FIELD SERVICE CAMPAIGN – 22104

10 May 2022

Antilock Brake System (ABS) Warning Light

IC Bus® RE Series vehicles

Figure 2. Chassis Fuse Block (Front View)

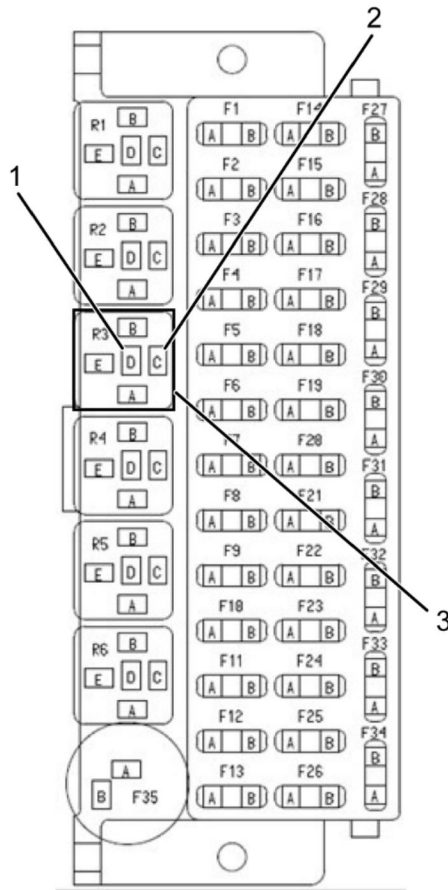
Certain IC Bus® RE Series buses may have the Antilock Brake System (ABS) indicator light circuit incorrectly pinned at the relay and may have an outdated BCM calibration that could result in the ABS indicator light illuminating at all times.

1. Fuse block bracket bolt (4)
 2. ABS warning light relay
 3. Fuse block bolt (2)
7. Remove ABS warning light relay (Figure 2, Item 2).
 8. Remove two fuse block bolts (Figure 2, Item 3). Save bolts for reuse
 9. Remove four fuse block bracket bolts (Figure 2, Item 1). Save bolts for reuse.
 10. Remove ABS warning light relay connector terminal lock. Save lock for reuse.

16. Install fuse block into fuse block bracket. Using torque wrench, tighten two fuse block bolts (Figure 2, Item 3) to 50 lb-in (5.7 N•m).
17. Install ABS warning light relay (Figure 2, Item 2) into fuse block.
18. Close fuse block cover and driver-side fuse panel access door (Figure 1, Item 1).
19. Using a wire brush, electronic contact cleaner, and compressed shop air, clean negative battery terminal components.
20. Apply BLUE dielectric grease to battery terminal stud, negative battery cable ring terminal, and threads of new battery stud nut.
21. Using new battery stud nut, reconnect negative battery cable to negative terminal on main vehicle battery and install new battery terminal nut.
22. Using torque wrench, tighten battery stud nut to 12 - 15 lb-ft (16 - 20 N•m).
23. Connect battery charger / maintainer to vehicle battery.
